**PLANNED UNIT DEVELOPMENT &  
SUBDIVISION STAFF REPORT****Date: June 29, 2003**

<b><u>DEVELOPMENT NAME</u></b>	Forrest Cove Subdivision
<b><u>SUBDIVISION NAME</u></b>	Forrest Cove Subdivision
<b><u>LOCATION</u></b>	South side of Moffett Road at the South terminus of Northview Drive
<b><u>PRESENT ZONING</u></b>	R-1, Single-Family Residential
<b><u>AREA OF PROPERTY</u></b>	214 Lots/66.7± Acres
<b><u>CONTEMPLATED USE</u></b>	Reduced lot widths and reduced lot sizes in a single-family residential subdivision
<b><u>TIME SCHEDULE FOR DEVELOPMENT</u></b>	Immediate
<b><u>ENGINEERING COMMENTS</u></b>	Must comply with all stormwater and flood control ordinances. Any work performed in the right of way will require a right of way permit.
<b><u>TRAFFIC ENGINEERING COMMENTS</u></b>	Driveway number, sizes, location and design to be approved by Traffic Engineering and conform to AASHTO standards.
<b><u>REMARKS</u></b>	The applicant is requesting Planned Unit Development and Subdivision approvals to construct a 214-lot, single-family residential subdivision with reduced lots widths and lot sizes.

# PLANNING COMMISSION VICINITY MAP - EXISTING ZONING

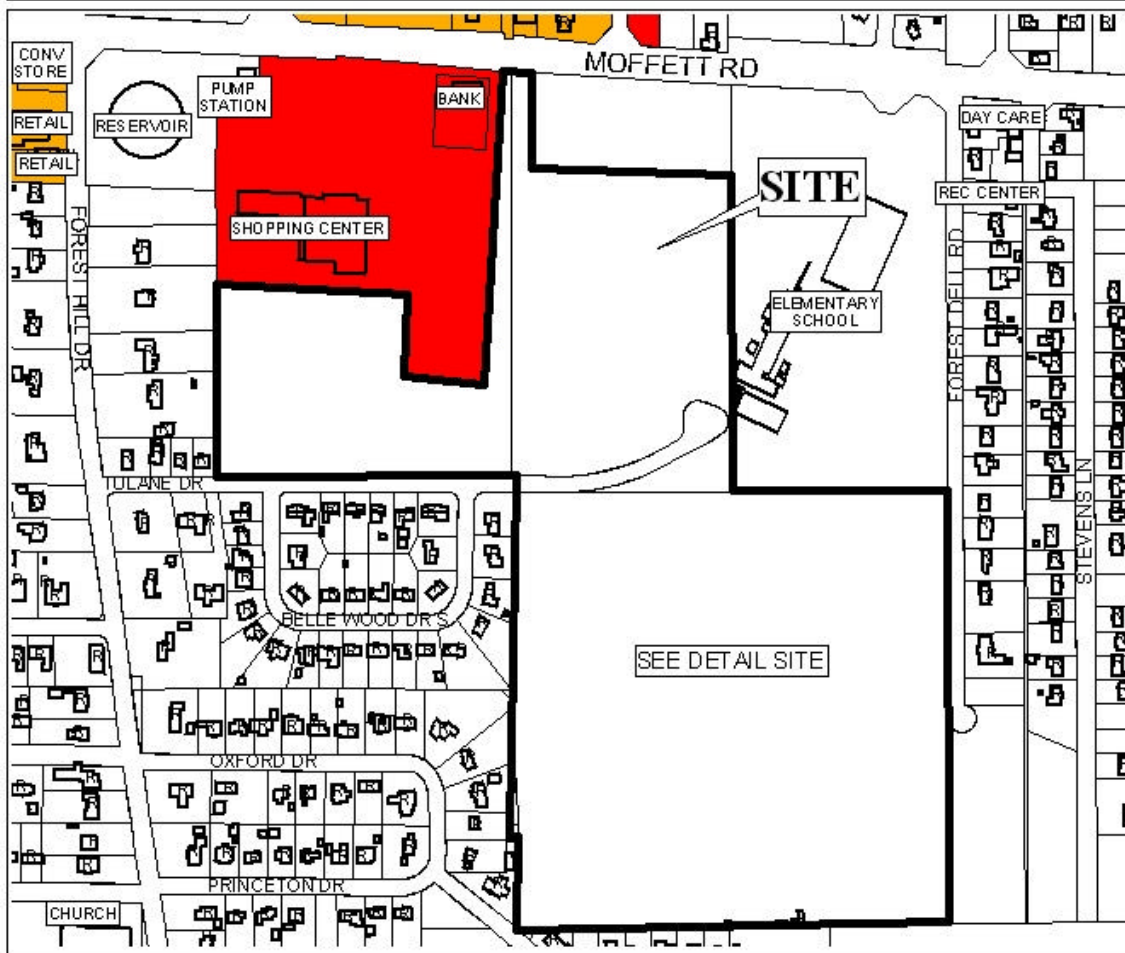
In terms of access and roads there are some concerns to address. First, the Vicinity Map indicates that Tulane Drive may extend eastward to the school site, and City Engineering and Planning Commission staff are researching the existence of actual right-of-way from a point approximately 150-feet East of Belle Woode Drive East, eastward. However, regardless of the existence of actual right-of-way, the "improvements" in this area are essentially a driveway standard, thus the road in this area (beginning approximately 150-feet East of Belle Woode Drive East eastward) must be improved to city standards. Furthermore, the provision of a cul de sac at the East end of Tulane Drive, should be required.

# DETAIL SITE PLAN

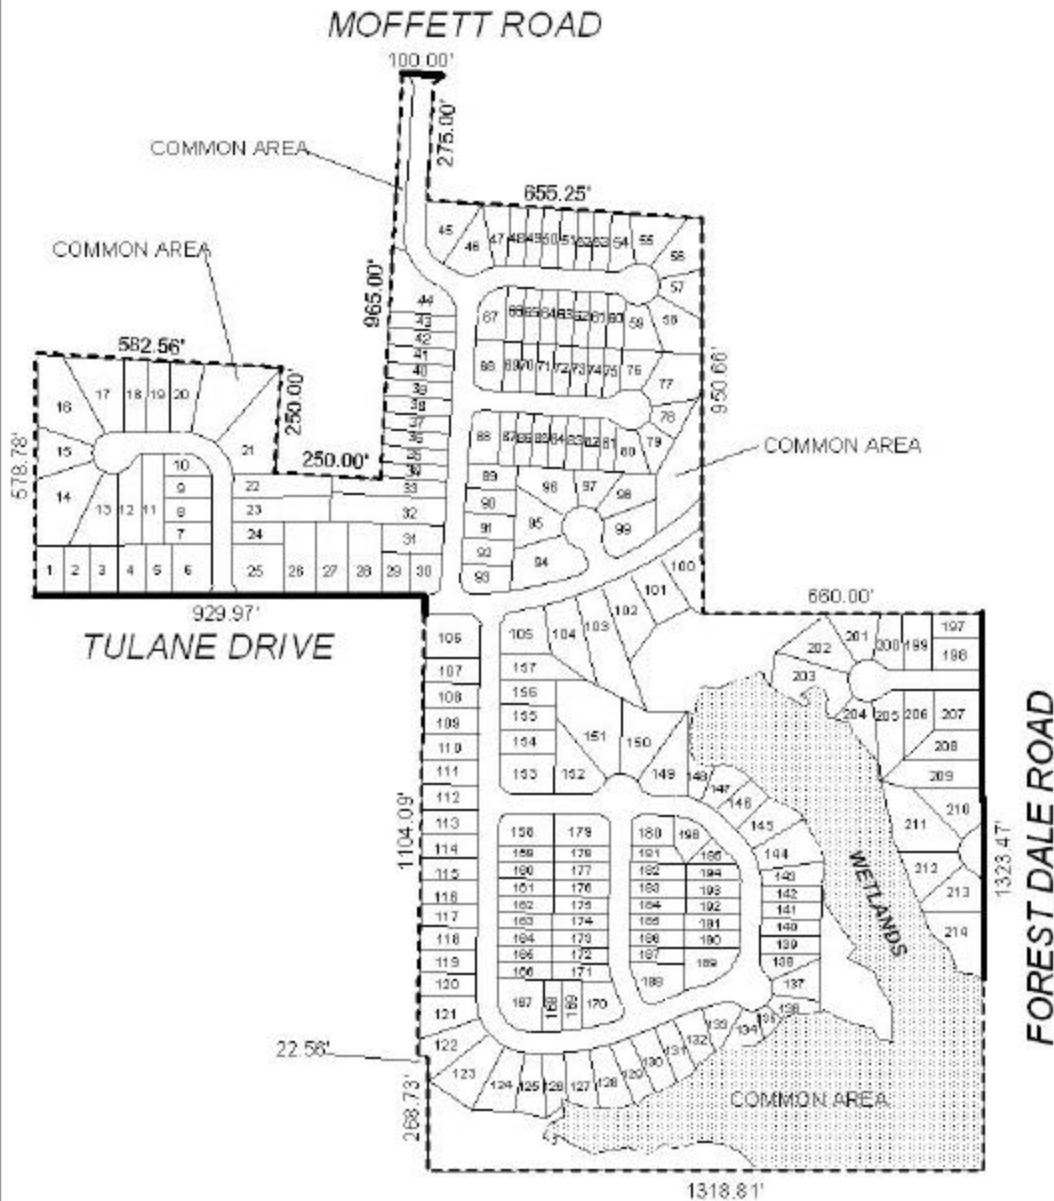
An additional consideration regarding access is that no more than 100 new lots should be developed with out providing a second point of access; i.e., the new street(s) connecting Moffett Road and Tulane Drive must be built prior to recording the 101<sup>st</sup> lot.

There are new lots proposed along Forest Dale Road, and Lots 210-214 will be located on a modified cul de sac. The design of the cul de sac should be coordinated with and approved by City Engineering, Traffic Engineering and Urban Development staff.

The site contains wetlands thus the area could be considered environmentally sensitive, therefore, the approval of all applicable federal, state and local agencies would be required.

Regarding the common areas, a note should be placed on the final plat stating that the maintenance of the common areas shall be responsibility of the property owners.

**Planned Unit Development:** Based upon the preceding, this application is recommended for approval subject to the following conditions: 1) construction of Tulane Drive to city standards, beginning approximately 150-feet East of Belle Woode Drive East eastward; 2) that no more than 100 lots be recorded with out providing a second point of access (connection between Moffett Road and Tulane Drive); 3) the provision of a cul de sac at the East end of Tulane Drive; 4) that the modified cul de sac along Lots 210-214 be coordinated with and approved by City Engineering, Traffic Engineering and Urban Development staff; 5) the obtaining of all applicable federal, state and local approvals; and 6) full compliance with all municipal codes and ordinances.

**Subdivision:** With modifications, and a waiver of Section V.D.2., the plat will meet the minimum requirements of the Subdivision Regulations and is recommended for Tentative Approval subject to the following conditions: 1) construction of Tulane Drive to city standards, beginning approximately 150-feet East of Belle Woode Drive East eastward; 2) that no more than 100 lots be recorded with out providing a second point of access (connection between Moffett Road and Tulane Drive); 3) the provision of a cul de sac at the East end of Tulane Drive; 4) that the modified cul de sac along Lots 210-214 be coordinated with and approved by City Engineering, Traffic Engineering and Urban Development staff; 5) the obtaining of all applicable federal, state and local approvals; and 6) placement of a note on the final plat stating that the maintenance of all common areas shall be the responsibility of the property owners.
